# TECHNICAL BULLETIN

**MODEL/DERIVATIVE:**  
**Discovery Series II (LT)**

**Bulletin N°:** 0022  
**CDS. ref:** L8945bu2  
**Issue:** 2  
**Date:** 29.7.2004

1

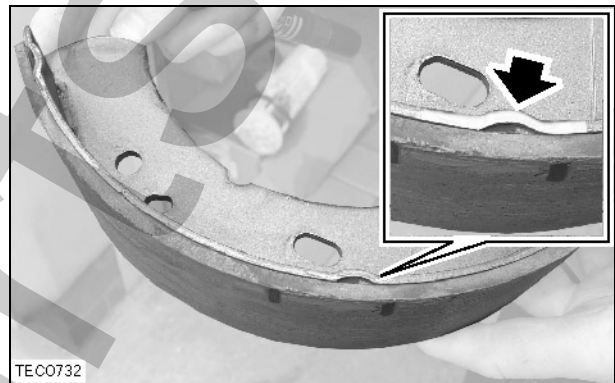
4. Remove the left-hand brake shoe (arrowed in illustration 1). On the rear face of the brake shoe mark 5 mm beyond the contact patch (see illustration 2).

3

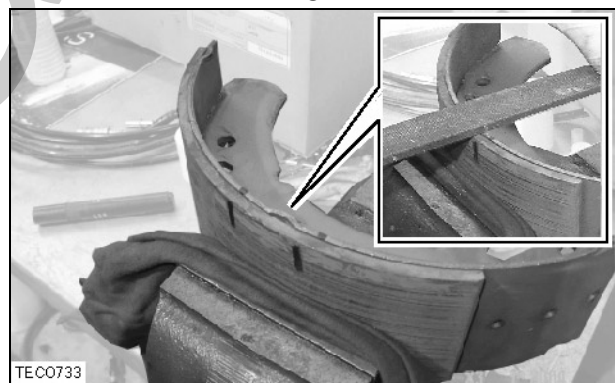
5. Place the brake shoe in a bench vice (protect the brake shoe lining) and using a file remove approximately 0.5 - 0.75 mm of metal from the brake shoe platform (see illustration 3).

4

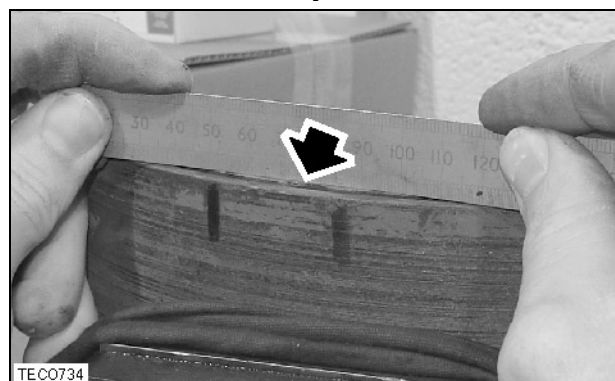
6. Ensure that a uniform amount of material has been removed between the marks by placing a straight edge across the top of the shoe platform (see illustration 4).
